HISTORIC AND DESIGN REVIEW COMMISSION

March 15, 2017

HDRC CASE NO: 2017-117
ADDRESS: 421 S ALAMO ST
423 S ALAMO ST
LEGAL DESCRIPTION: NCB 155 BLK 4 LOT 10 & E IRR 240.51 FT OF 4 & 5
ZONING: D,HE
CITY COUNCIL DIST.: 1
DISTRICT: La Villita Historic District
LANDMARK: German-English School
APPLICANT: Guy Chipman III/Guy Chipman Construction, L.P.
OWNER: HH San Antonio LLC c/o Ashford Hospitality
TYPE OF WORK: Door replacement
REQUEST:

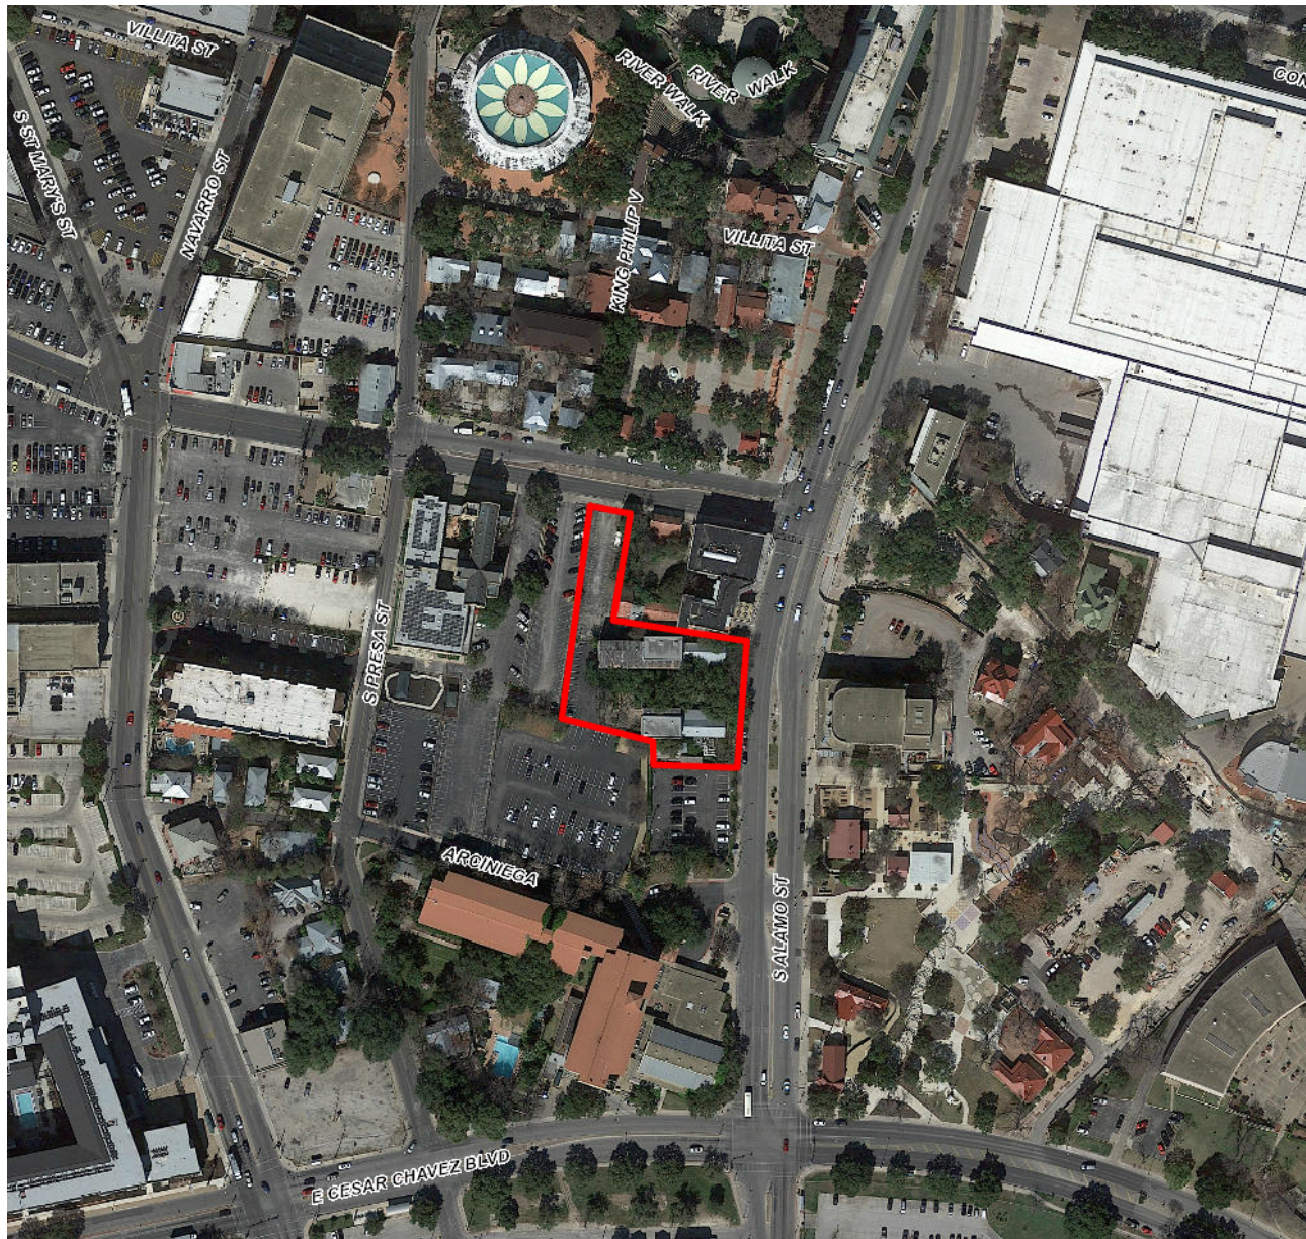
- b. The applicant has requested to replace four sets of exterior doors on the southeast building with replica replacement doors. The applicant has determined these doors to be deteriorated beyond repair and insufficient for modern security needs. Existing framework will be repaired where necessary and original openings will be preserved.

- c. Staff visited the property on February 23, 2017 and assessed the condition of the exterior doors to be replaced. Staff determined that the doors had been subjected to decades of piecemeal repair and replacement, as well as extensive damage to wood stiles and joints due to insufficient door stops. Large panels of painted plywood were also affixed to the interior face of the doors to prevent the glazing from falling inward. One door panel had an improper muntin affixed to the glazing panel. Staff also found that some previous repair methods, if removed, would result in further damage to original wood elements. Based on these assessments, staff has determined that the doors are deteriorated beyond repair. According to the Guidelines for Exterior Maintenance and Reconstruction, doors should be replaced in-kind when deteriorated beyond repair. Staff has photodocumented the existing doors in situ and finds the proposal consistent with the guidelines. Staff finds that salvaging original wood elements would also be appropriate and consistent with the Guidelines.

Staff recommends approval based on findings a through c with the following stipulations:

- i. The applicant photographs the removal and deconstruction of the original doors and provides images to staff.
- ii. Original wood elements be salvaged and reused in the new doors where feasible.
